MCFADDIN BUTTRESS REPAIR
+ LEANING CHIMNEY REMOVAL

ADDENDUM NO. 1

January 27, 2026

Item 1. Drawing SP1.0 – Site Plan

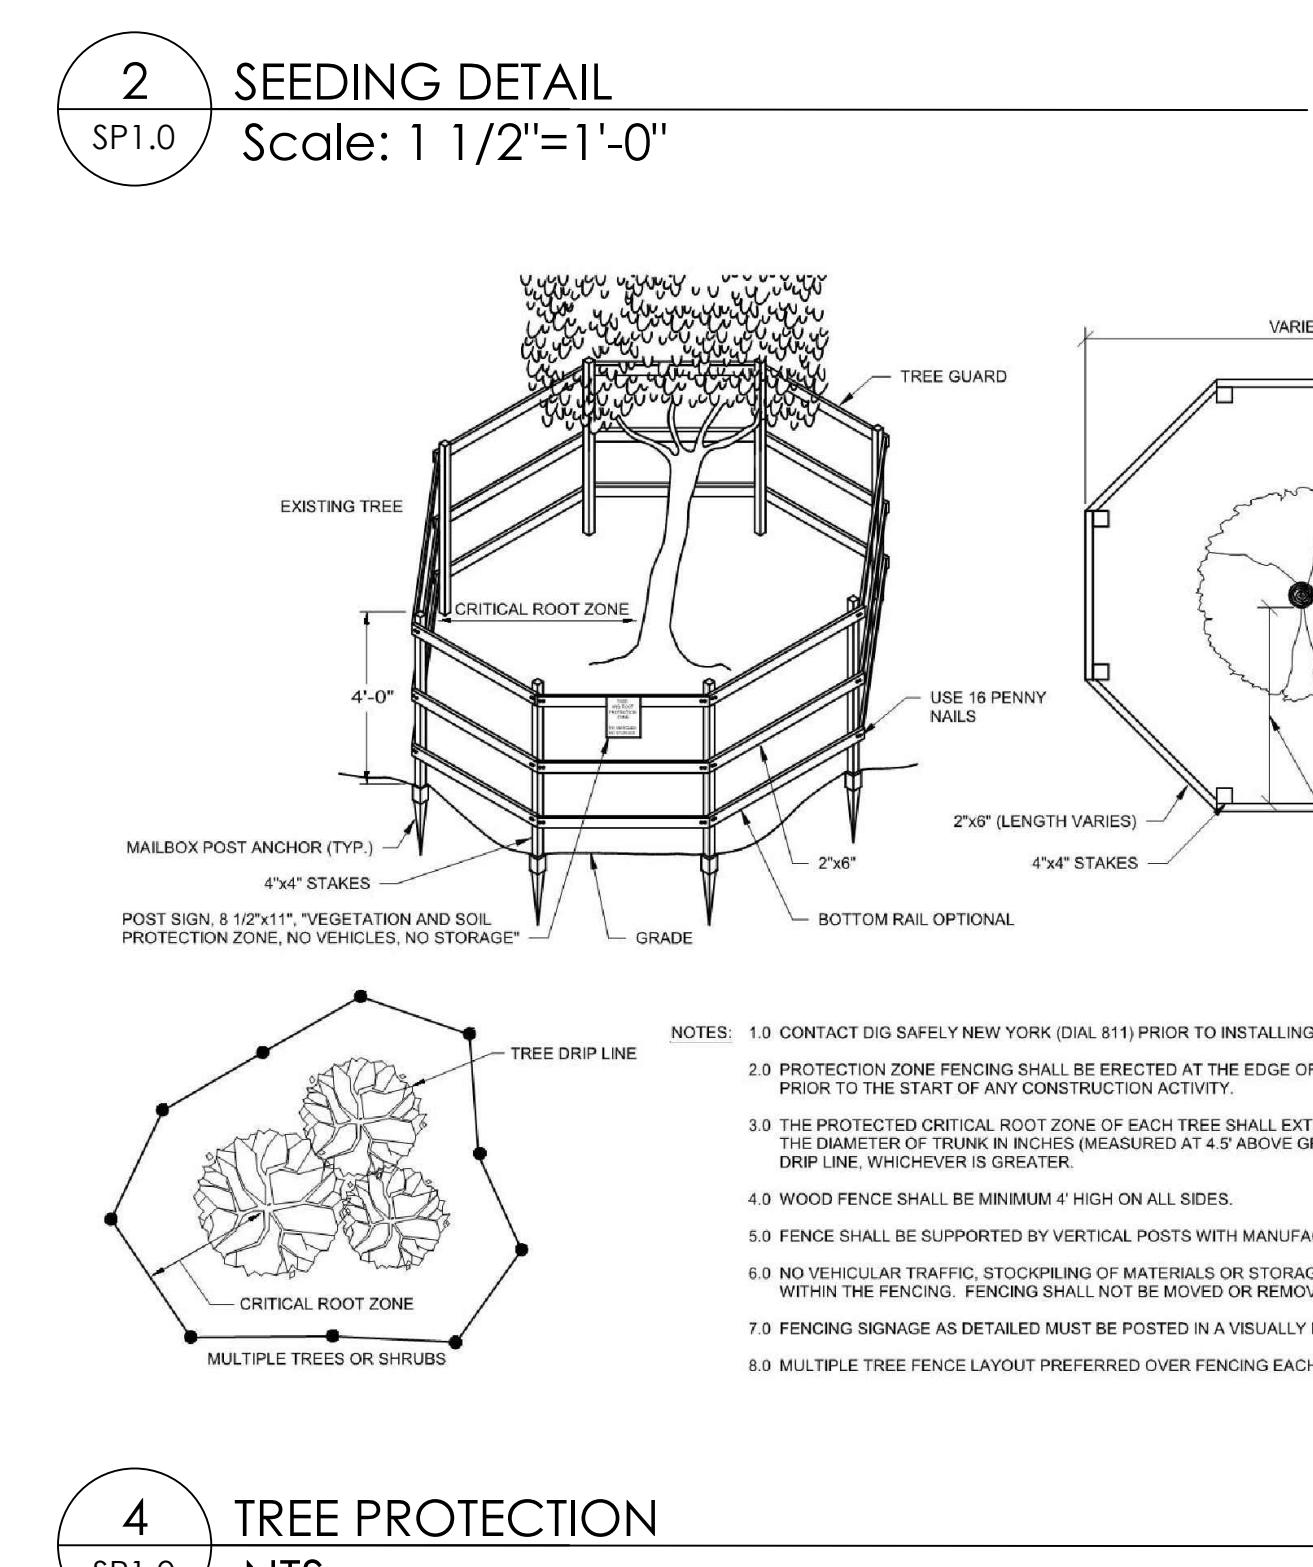
DELETE in its entirety.

REPLACE with revised Drawing SP1.0 dated January 22, 2026, attached.

Mortar
Color
Close -
Possibly a
bit darker

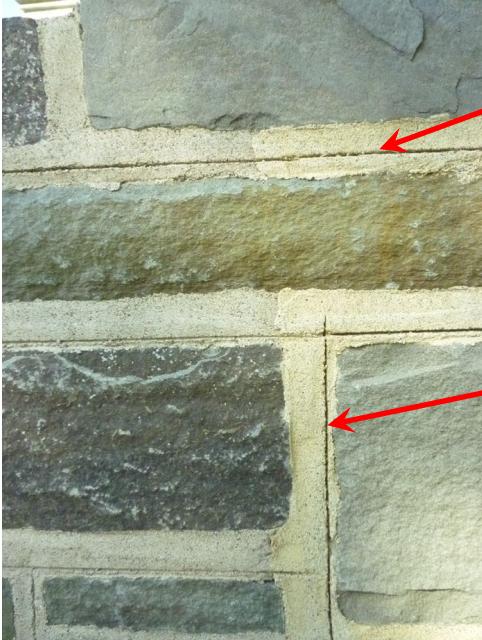
<p>Stone appears face bedded</p> <p>May not be a natural face-guillotine cut?</p>
1.3	<p>Pointing Mortar</p> <p>The pointing mortar color on the left hand side of the mock-up appears close to the original mortar color. This may need to be slightly darkened. The mortar on the right is a bit too bright and yellow.</p> <p>The mortar joint size and irregularity looks good and matches the original.</p> <p>The mortar joint profile does not match the original. The joint was scored but mortar was not removed below and to the side of the scored line to create the shadow effect apparent on McFaddin. See detail noted in mock-up drawing and existing joints on McFaddin for reference.</p>	<p>Alliance to emulate the joint profile in the second half of the mockup.</p>

Scored line should be
slightly higher with
mortar removed from
below line to edge of
stone

Scored line should be
slightly further from edge
of stone with mortar
removed from line to
edge of stone

Alliance to
build second
half of
mockup with
this mortar
color on half
and half with
a slightly
darker color.

<p>*12/10/25 Color of mortar and joint technique appears very close to the original.</p>
1.4	<p>"Stippled" Corners</p> <p>The chiseled or "stippled" faces look appropriate and are well done. MCWB suggests the following for improvement: more evenly distribute stippled patterns across whole face of the stone.</p>	
	 <div style="border: 2px solid red; padding: 5px; display: inline-block;"> <p>This area has no stippling</p> </div>	
	<p>Stippled face is appropriate and well done. MCWB suggests stippling could be more evenly distributed.</p>
